IN THE UNITED STATES PATENT AND TRADEMARK OFFICE the Application of: Yasushi KANEKO

TRANSFLECTIVE LIQUID CRYSTAL DISPLAY DEVICE

PRELIMINARY AMENDMENT

REQUEST FOR APPROVAL OF DRAWING CHANGES

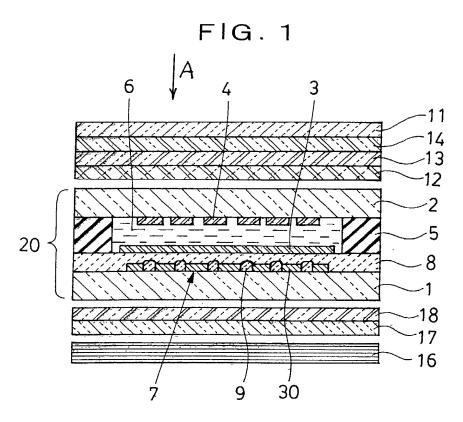
Attached hereto is a Request for Approval of Drawing Changes. Attached to the Request are copies of Figs. 1, 7 with the changes indicated in red. Upon the approval of the Examiner, Applicant will take the necessary steps to secure a bonded draftsman to effect the approved changes after allowance.

The Examiner's approval of the drawing correction indicated in red ink on the attached sheet of drawings(Figures 1, 7) is respectfully requested.
